6. CASE 23.111, 535 BROADWAY, House, c1880 (BROADWAY)

Proposal: The scope of work proposed consists of Major Alterations and includes:

Project: Three-Family Residence
Address: 535 Broadway, Providence, RI 02909
Date: 28 August 2023
Re: Application Information

PROPOSED WINDOW SASH REPLACEMENT
THREE FAMILY BUILDING
535 BROADWAY
PROVIDENCE, RHODE ISLAND 02909

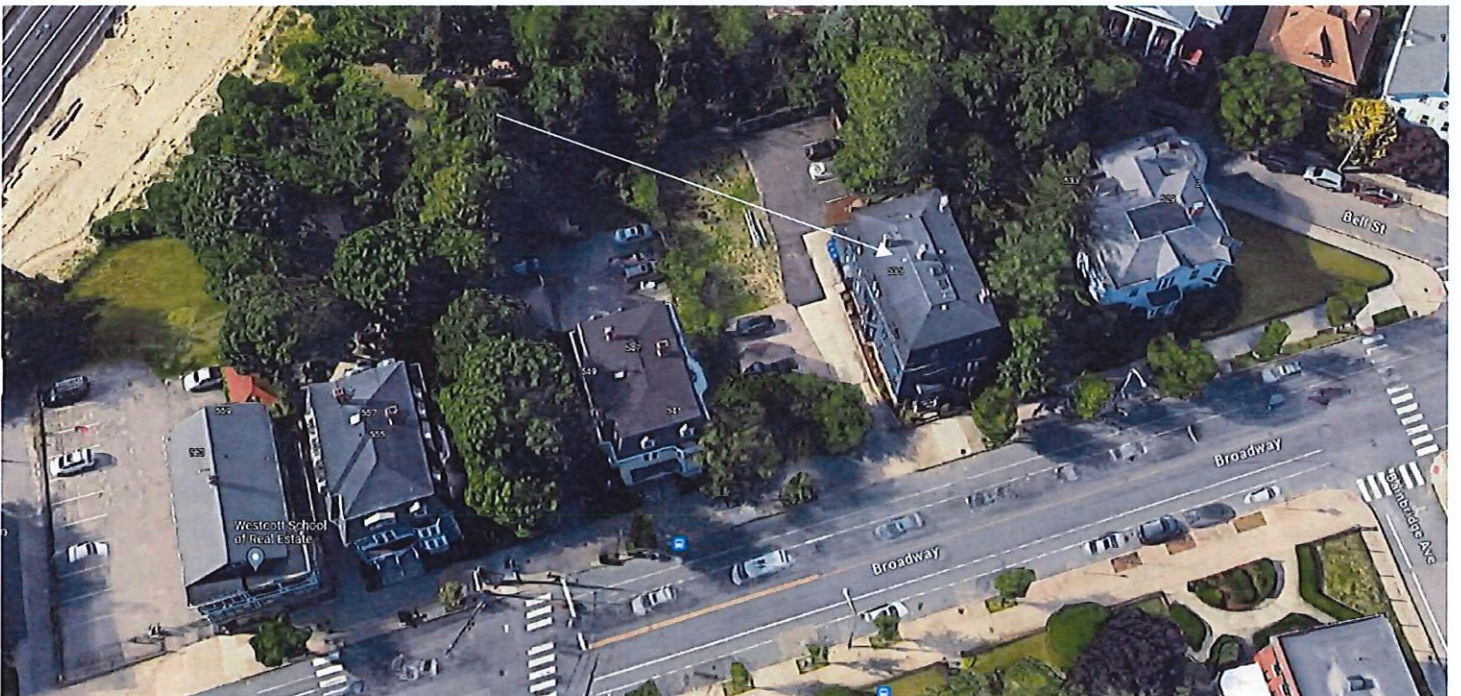
- **Evaluation:** At present the windows are in fair condition and are wood frame with single pane glazing. The current DH configurations: 2/2 and 1/1. (see schedule). **Sash Replacement:** We propose to replace seven (7) units on the first floor in a Kitchen, Bathroom and Bedroom. The replacement sashes shall be as follows: The new double hung sashes shall be Trimline Ultra Fit (Classic Clad) sash replacement kit. These are wood units, insulated glazing with aluminum clad exterior and vinyl jamb liners. Muntins to be simulated divided light. Exterior color to be black. New window screens to be half-window. All will remain in their original 2/2 or 1/1 configuration and all window sizes shall remain the same. The existing sashes and aluminum storm windows shall be removed

- The Owner would like to replace the existing sashes with new sashes for three reasons: **Energy Efficiency** – The new sashes, with insulated glass, and more efficient jamb liners and function are an improvement in air infiltration and U-value over the existing single pane windows with storm windows. The existing storm windows have weep holes in the sill which allow air to enter the building. Also, the weight pockets are to be filled with spray foam insulation to complete the envelope insulation. **Aesthetics** – The Owner is willing to install replacement window sashes which are nearly identical to the existing ones. The muntin size and spacing will be matched. The difference in glass area reduction is 2% for unit "A". From the exterior, the new sashes, along with removal of the storm windows, will result in windows which are close to the original in size, function, appearance and profile depth with windows within the wall plane, which is diminished by the storm windows. **Lead Safety** – The removal of the existing painted wood sashes, combined with the new sash operation with greatly reduce lead exposure within the building

- The alterations are not visible from the public rights-of-way;
- The house is a multi-family and is required to obtain a lead-safe certificate for compliance with RIGL § 42-128.1-8; and,

Recommendations: The staff recommends the PHDC make the following findings of fact:

- a) 535 Broadway is a structure of historical and architectural significance that contribute to the significance of the Armory local historic district, having been recognized as a contributing structure to the Broadway/Armory National Register Historic District;
- b) The application for Major Alterations is considered complete; and,
- c) The work as proposed is in accord with PHDC Standard 8 as follows: as the proposed alterations are appropriate having determined that the proposed construction is architecturally and historically compatible with the property and district having an appropriate size, scale and form that while diminishing the historic quality of the property will not have an adverse effect on the property or district as the alterations are not visible from the public rights-of-way and allows the property to come into compliance with RIGL § 42-128.1-8.

Staff recommends a motion be made stating that: The application is considered complete. 535 Broadway is a structure of historical and architectural significance that contribute to the significance of the Armory local historic district, having been recognized as a contributing structure to the Broadway/Armory National Register Historic District. The Commission grants Final Approval of the proposal as submitted having determined that the proposed alterations are appropriate as the proposed alterations are architecturally and historically compatible with the property and district having an appropriate size, scale and form that while diminishing the historic quality of the property will not have an adverse effect on the property or district as the alterations are not visible from the public rights-of-way and allows the property to come into compliance with RIGL § 42-128.1-8, citing and agreeing to the recommendations in the staff report, with staff to review any additional required details.
